# Rio Algom Mining LLC

Re: **License SUA-1473, Docket No. 40-8905**  
**Editorial and Administrative Amendment to SUA-1473**  
**Justification for Removal of Gross Alpha from SUA-1473 Monitoring Requirements**

## TECHNICAL MEMORANDUM

Re: Justification for Removal of Gross Alpha from SUA-1473 Monitoring Requirements

**Figure B1. Gross Alpha Activities in  
Dakota Monitor Well 36-06 KD**

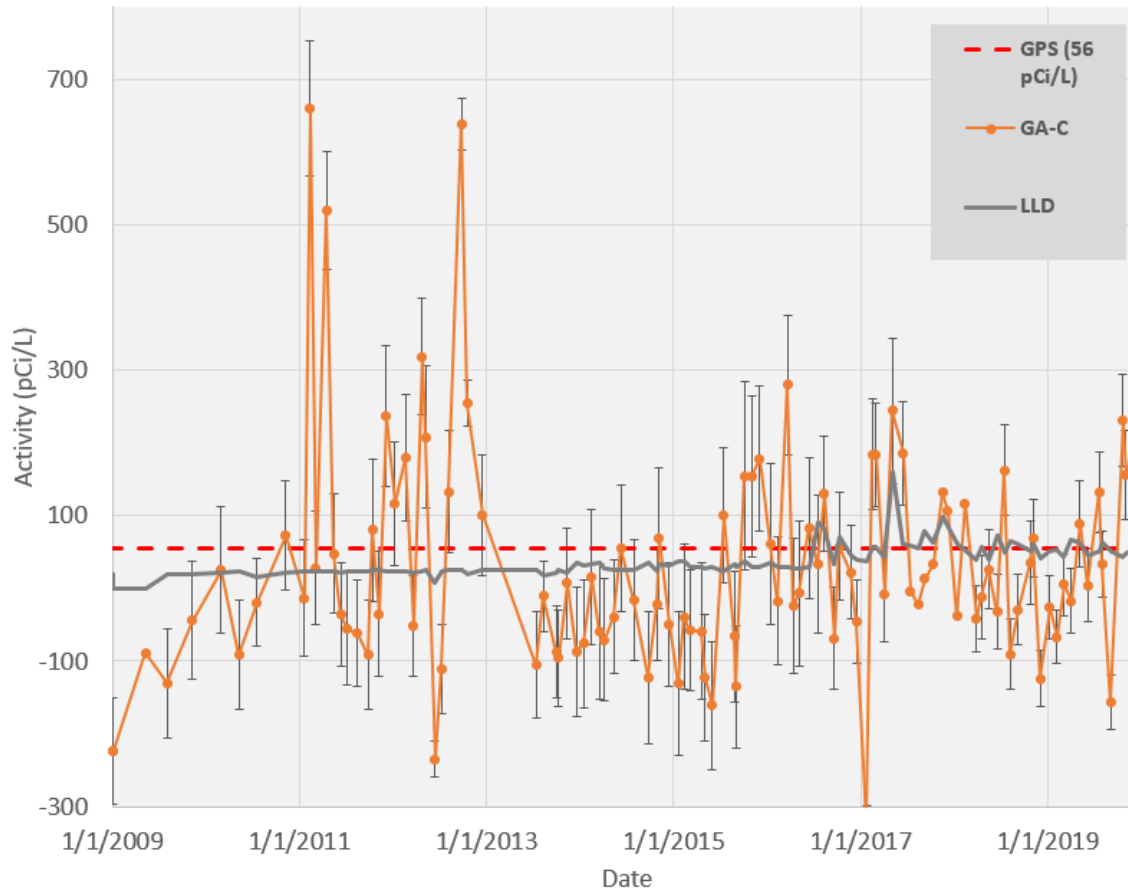
**Figure B.1.** Uncertainties for GA measurements are significant. The Lower LLD is less than or equal to the Dakota GPS of 56 picoCuries per liter (pCi/L). Most corrected GA results are below both the GPS and LLD. Exceedances are often within  $2\sigma$  of the GPS. Uncertainties are typically between 70-100 pCi/L. Note that 36-06 KD has been monitored since 1988, but LLDs and uncertainty are generally not available for data collected prior to 2009.

Note that many corrected GA values are negative; some of these are not even within  $2\sigma$  of zero.

**Figure B.2. Gross Alpha Activities in  
Tres Hermanos B Monitor Well 31-02 TRB-R**

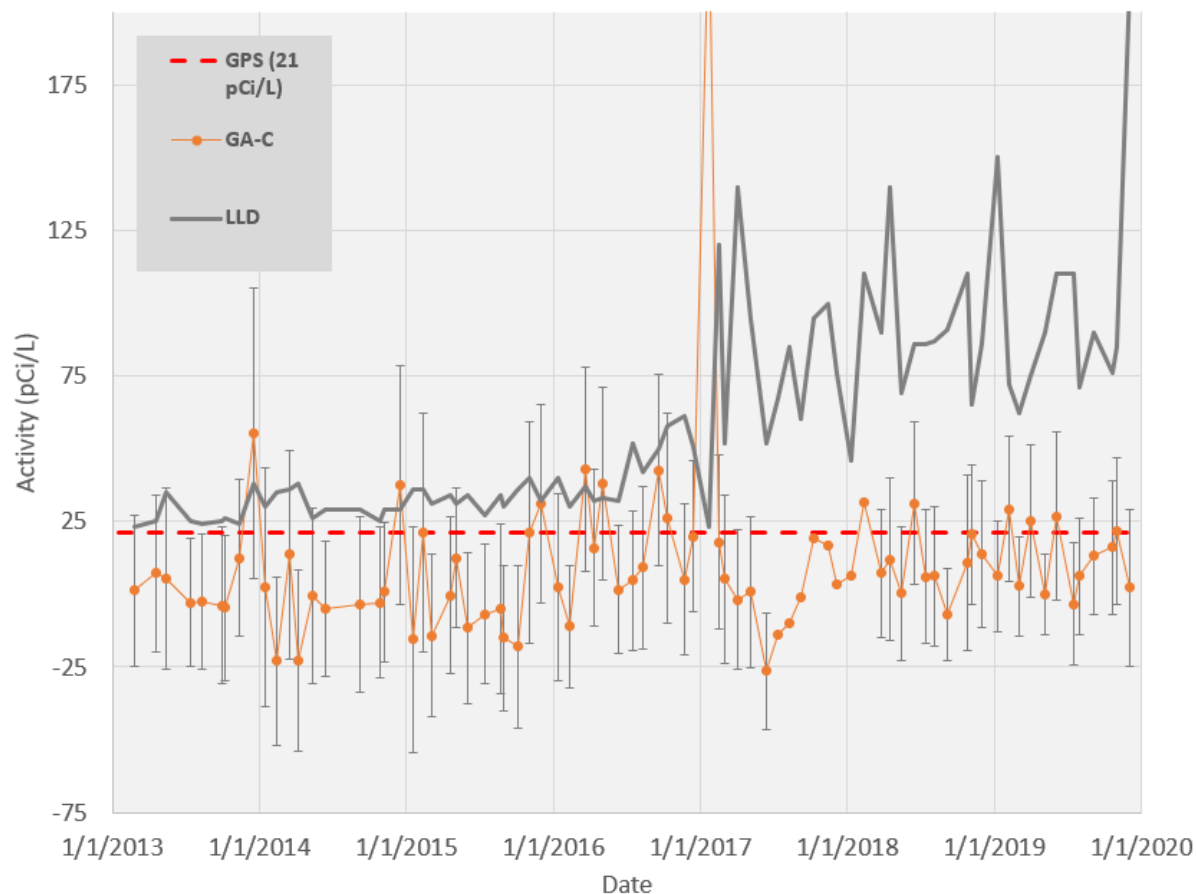
**Figure B.2.** Uncertainties for GA measurements are significant relative to the TRB GPS of 21 pCi/L. The LLD (grey) exceeds the TRB GPS for all but 4 results. Combined with the relatively larger reported uncertainties, there has never been a statistically significant detection of GA at 31-02 TRB-R. At 31-02 TRB-R, uncertainties are typically between 30-40 pCi/L. Note that the off-scale value is 237 pCi/L (January 2017).

**Figure B.3. Gross Alpha Activities in  
Dakota Monitor Well 32-45 KD-R**

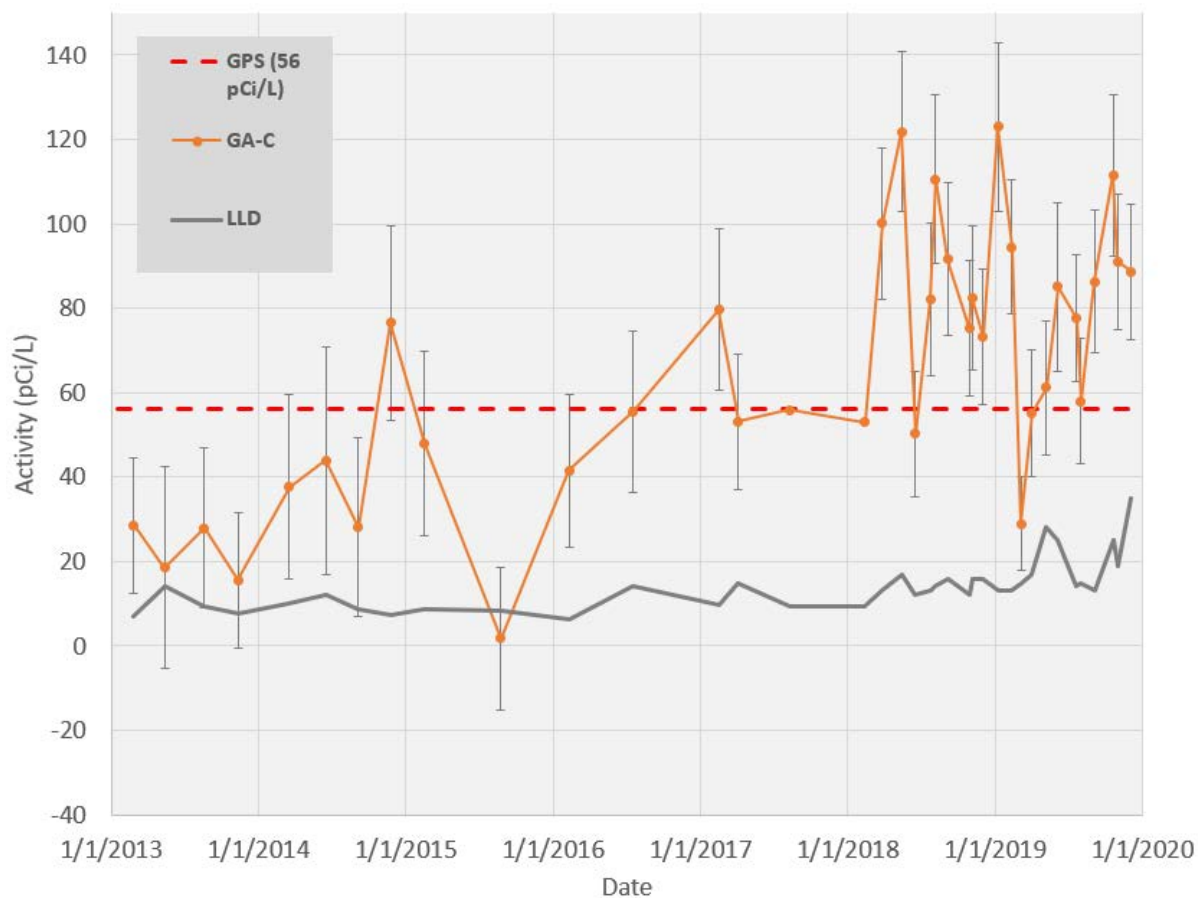
**Figure B.3.** Groundwater from 32-45 KD-R contains less TDS than 36-06 KD or 31-02 TRB-R. The LLD for all measurements is below the KD GPS of 56 pCi/L. Uncertainties are typically between 20-30 pCi/L.
